General Bid Bulletin No. 19
30 July 2021

**THE MALOLOS-CLARK RAILWAY PROJECT AND THE NORTH-SOUTH RAILWAY
PROJECT SOUTH LINE COMMUTER PACKAGE CP NS-01: PROCUREMENT OF
ELECTRICAL AND MECHANICAL SYSTEMS AND TRACK WORKS (IFB No: 21-040-3)**

This General Bid Bulletin is issued to amend/clarify certain provisions in the Bidding Documents for the above-mentioned Project. Please refer to the attached Annexes of this General Bid Bulletin for details:

SHEET No. 3 OF 45
 DRG No. NSRP-DWG-PSS-0000
 DRG S. -

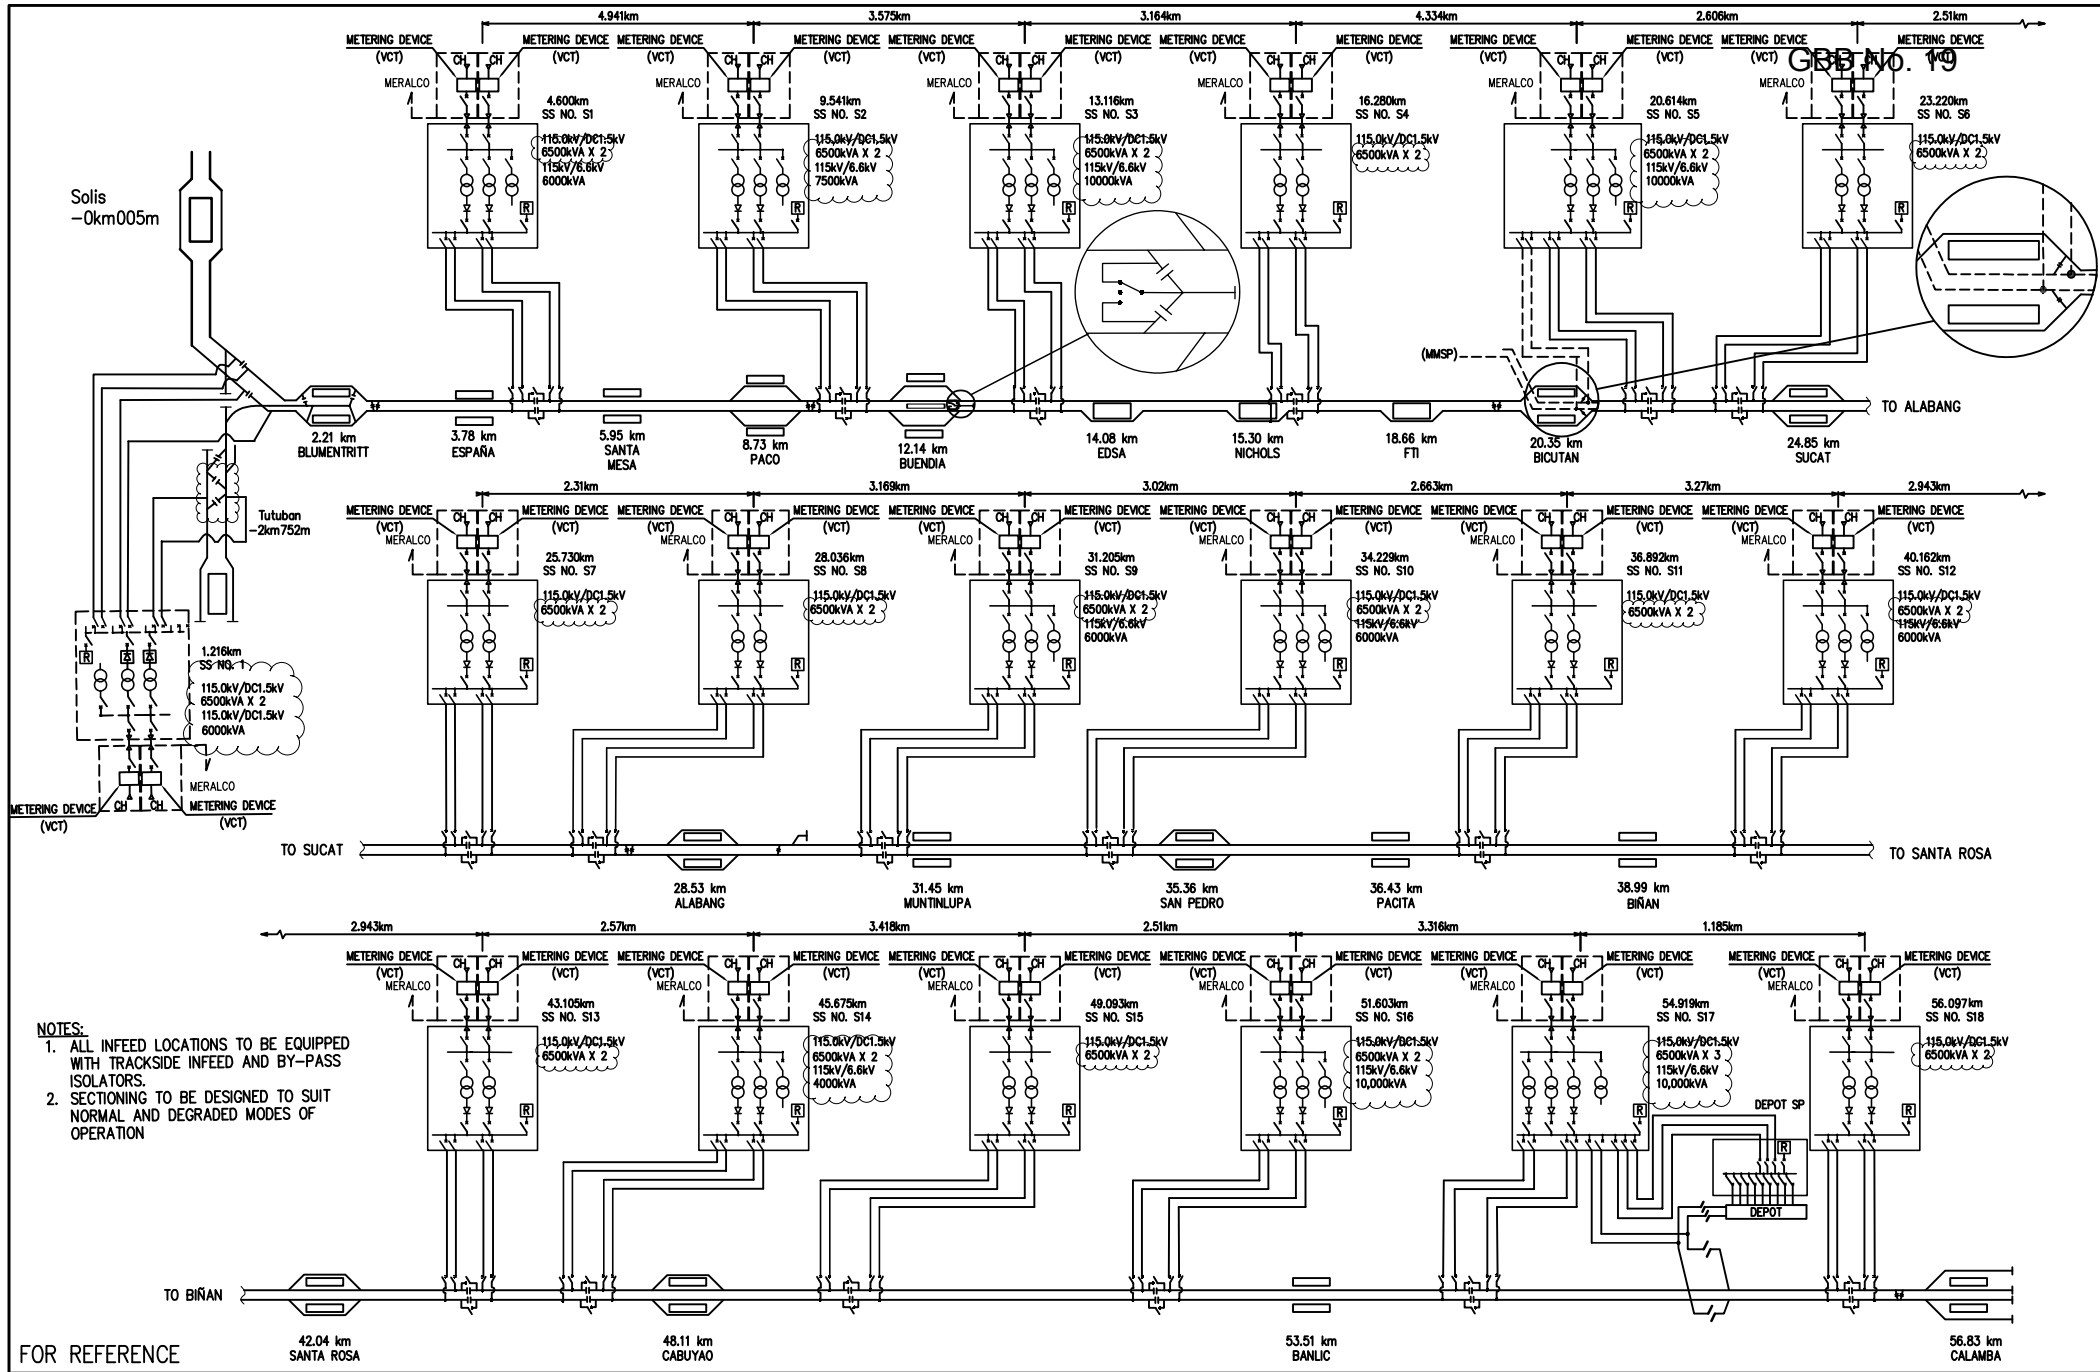
commencement of the design and shall remain the property of the Employer on completion of the contract
10	ERT 590: Table 6.4.7	Update Nominal Strength= 18N/mm ²
11	ERT 646: Part 2 Section VI Technical Requirements – AFC Table 7-6	Table 7-6 Peak Hour Passenger Demand updated.
12	ERT 50: 1.23 26) :	New clause added: On the viaduct sections drilling into the deck shall not be permitted and the contractor shall design and install a plinth into which walkway fixings can be attached. The exception to this is the CP05 area where drilling to the deck is permitted subject to the precautions regarding damage to the civil works are approved and implemented.
13	ERG 186: Appendix 8	ERG 186 Appendix 8- Outline of demarcation updates.
Volume III Part 2 – Employer’s Requirements d) Employer’s Drawings		
14	NSRP-DWG-PSS-0000 REV.08 GBB 12, page 166	Revised the drawing issued in GBB12 with drawing “NSRP-DWG-PSS-0000 REV.10”

VERSIONS	DATE	DESCRIPTION
05	25 MAY 2021	SS NO.1 REVISED
06	15 JUN 2021	DISTRIBUTION TRANSFORMER CAPACITY CHANGED
07	17 JUN 2021	BUENDIA,SUCAT & SANTA ROSA STATIONS MODIFIED
08	24 JUN 2021	RECTIFIER TRANSFORMER CAPACITY CHANGED & SS NO.8,SS NO.9 & SS NO. 18 CHAINAGE REVISED
10	13 JUL 2021	ISOLATORS ADDED AT SBT
